**PCN# 20120620001
TPS769XX-Q1 datasheet - CMS C1206063
Information Only**

PCN Number:	20120620001			PCN Date:	06/27/2012
Title:	TPS769XX-Q1 datasheet - CMS C1206063				
Customer Contact:	PCN Manager	Phone:	+1(214) 480-6037	Dept:	Quality Services
Change Type:					
<input type="checkbox"/>	Assembly Site	<input type="checkbox"/>	Assembly Process	<input type="checkbox"/>	Assembly Materials
<input type="checkbox"/>	Design	<input checked="" type="checkbox"/>	Electrical Specification	<input type="checkbox"/>	Mechanical Specification
<input type="checkbox"/>	Test Site	<input type="checkbox"/>	Packing/Shipping/Labeling	<input type="checkbox"/>	Test Process
<input type="checkbox"/>	Wafer Bump Site	<input type="checkbox"/>	Wafer Bump Material	<input type="checkbox"/>	Wafer Bump Process
<input type="checkbox"/>	Wafer Fab Site	<input type="checkbox"/>	Wafer Fab Materials	<input type="checkbox"/>	Wafer Fab Process

Texas Instruments publication SGLS118B will change as described below:

Figure 17

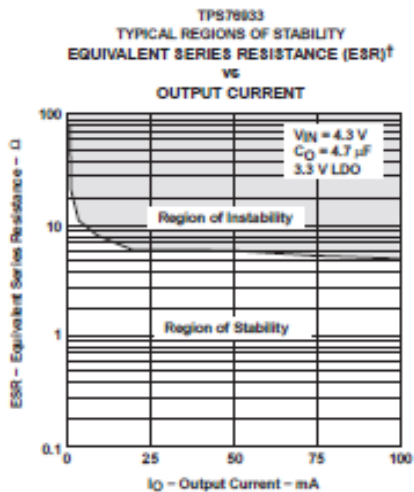
Page 10, Figures 17 and 19, Equivalent Series Resistance (ESR) versus Output Current graphs **changed from:**

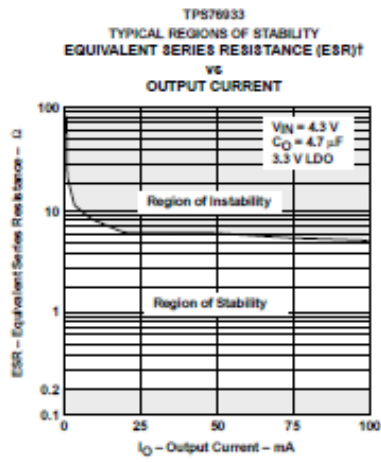
Page 10, Figures 17 and 19, Equivalent Series Resistance (ESR) versus Output Current graphs **changed to** (a region of instability from 0.2 ohms and below has been added):

Reason for Change:	
Correct device typical characteristics.	
Anticipated impact on Fit, Form, Function, Quality or Reliability (positive / negative):	
No anticipated impact. This is a specification change announcement only. There are no changes to the actual device.	
Changes to product identification resulting from this PCN:	
None	
Product Affected:	
TPS76901QDBVRG4Q1	TPS76925QDBVRG4Q1
TPS76901QDBVRQ1	TPS76925QDBVRQ1
TPS76912QDBVRG4Q1	TPS76930QDBVRQ1
TPS76912QDBVRQ1	TPS76933QDBVRG4Q1
TPS76915QDBVRG4Q1	TPS76933QDBVRQ1
TPS76915QDBVRQ1	TPS76950QDBVRG4Q1
TPS76918QDBVRQ1	TPS76950QDBVRQ1
